Clarence Cannon Dam and Reservoir: Cost, Schedule, and Safety Problems. PSAD-77-131; B-181997. July 18, 1977. 17 pp. + 3 appendices (6 pp.).

Report to the Congress; by Elmer B. Staats, Comptroller General.

Clarence Cannon Dam And Reservoir: Cost, Schedule, And Safety Problems

**Corps of Engineers (Civil Functions)
Department of the Army**

CROSS SECTION OF DAM SHOWING SUSPECT PHASE I FILL MATERIAL

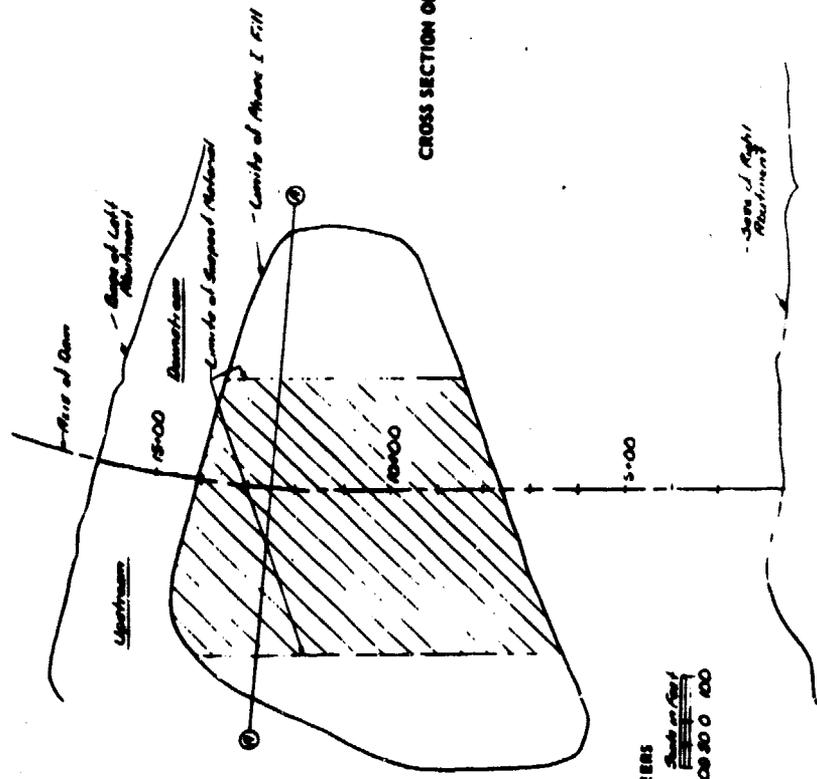
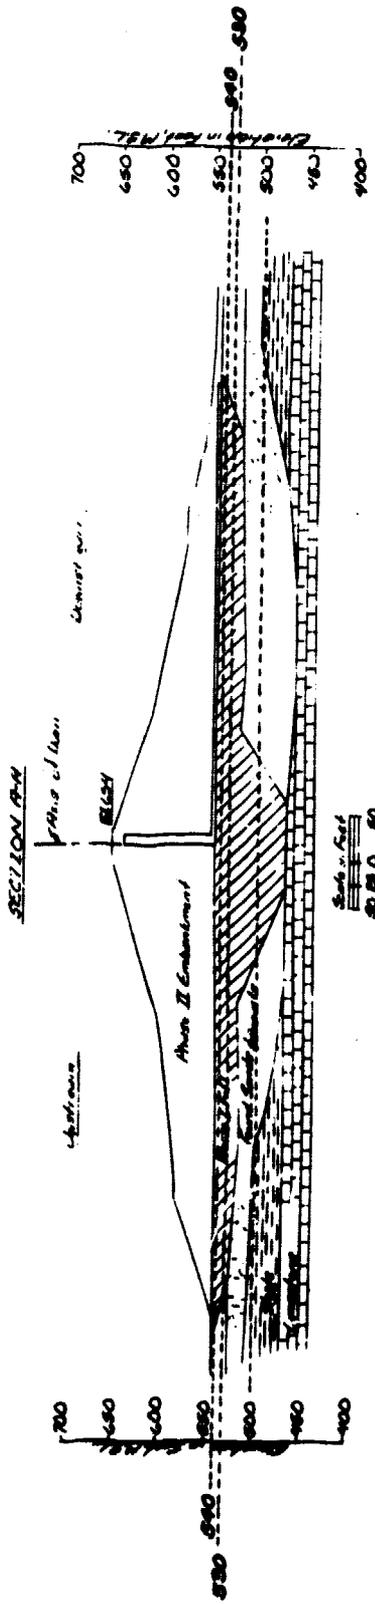
The Cannon main dam, an earthen structure, may not be as safe as originally designed because wet fill material was used in the foundation. Incorrect contract specifications and unresolved differences on the fill's optimum moisture content contributed to the use of wet fill material. A Corps study shows this contract specification error reduces foundation design strength. However, the Corps has concluded that, when completed, the dam will still exceed its design standards.

About 6 months after the phase I contract was awarded, the Corps realized that contract specifications allowed a 3-percent above optimum moisture content rather than the 2 percent prescribed in design specifications.

A study showed that a 3-percent limit would reduce the foundation strength 15 percent. During 1972, tests of the partially completed phase I fill showed that portions of the fill between elevation 530 and 540 contained excessive moisture. Although agency officials were aware of the moisture problems when a substantial amount of the fill was yet to be placed, they did not revise the contract specifications or require replacement of the substandard fill. Instead they emphasized the need for better controls to assure that the remaining fill did not exceed the 3-percent limit.

In January 1973 the district engineer proposed to replace the substandard fill because he was "* * * convinced that this material is not acceptable under any conditions." In March 1973 a conference involving several levels of Corps management evaluated the problem and decided to leave the fill in place assuming that more stringent specifications and quality control for the upper portion of the earthen dam would produce adequate average strength. This decision was based on shear tests and stability analyses which indicated a significant number of low shear strength areas primarily between elevations 530 and 540. The conferees agreed that this approach involved some risk and decided that additional instruments should be placed in both the fill and in the earthen dam while it was under construction, to see if critical shear strains or strength problems developed. Headquarters and division officials both stressed the need for better inspection and quality control on the phase II work.

Since the 1973 decision, some of the instruments have become inoperable because of accidents and the Corps has questioned the reliability of data from other instruments. Corps officials concluded that until construction of phase II of the earthen dam is underway in 1978, they will not know how much overall strength loss will result from the substandard fill. The phase II dam contract includes an option to have the fill removed at a cost of about \$237,000. However, this will be economically unrealistic after very much of the earthen dam is completed. Should strength loss be significant after construction for phase II starts, it would be possible to compensate by enlarging the sides of the dam. The Corps has not determined the cost and schedule impact of this alternative.

Therefore, we recommend that the Secretary of the Army obtain an evaluation of the overall safety of the project from an expert, independent consultant.
